Intel® Desktop Board D865GBF Specification Update

Release Date: November 2004

Order Number: C41597-013

Figure 29a. Omnidirectional Airflow Heatsink

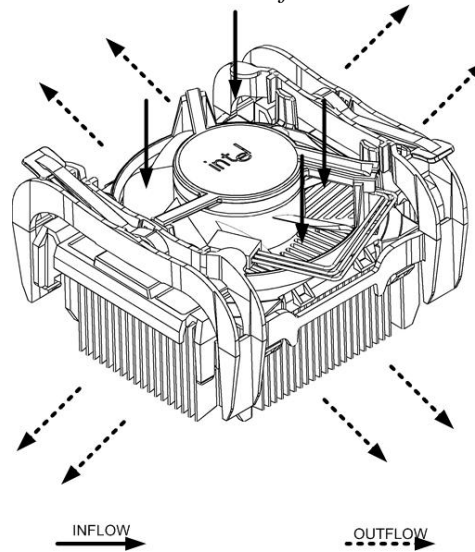
5. Change to Thermal Considerations, Section 2.12

Section 2.12, Thermal Considerations will change in its entirety as follows:

The use of an Intel Pentium 4 processor with 1 MB of L2 cache on this Intel desktop board requires the following:

- A chassis with a maximum internal ambient temperature of 38 Degrees Celsius
- A processor heatsink that provides omnidirectional airflow so that air is drawn across the processor voltage regulator area (item A in Figure 30). Figure 29a illustrates an omnidirectional airflow heatsink.

Figure 30. Localized High Temperature Zones

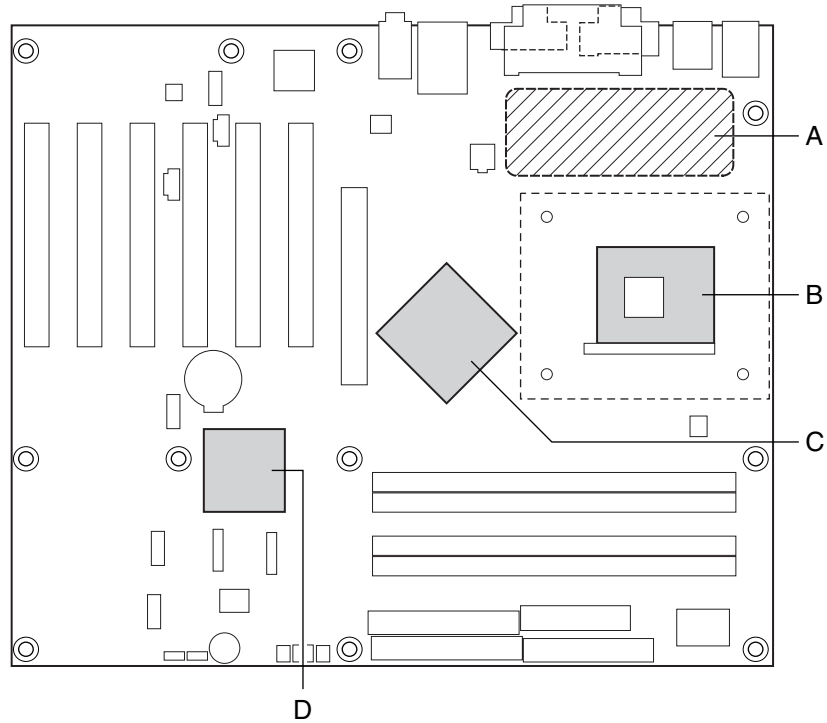
Ensure that proper airflow is maintained in the processor voltage regulator circuit. Failure to do so may result in damage to the voltage regulator circuit. The processor voltage regulator area (item A in Figure 30) can reach a temperature of up to 85 °C in an open chassis.

Figure 30 shows the locations of the localized high temperature zones.
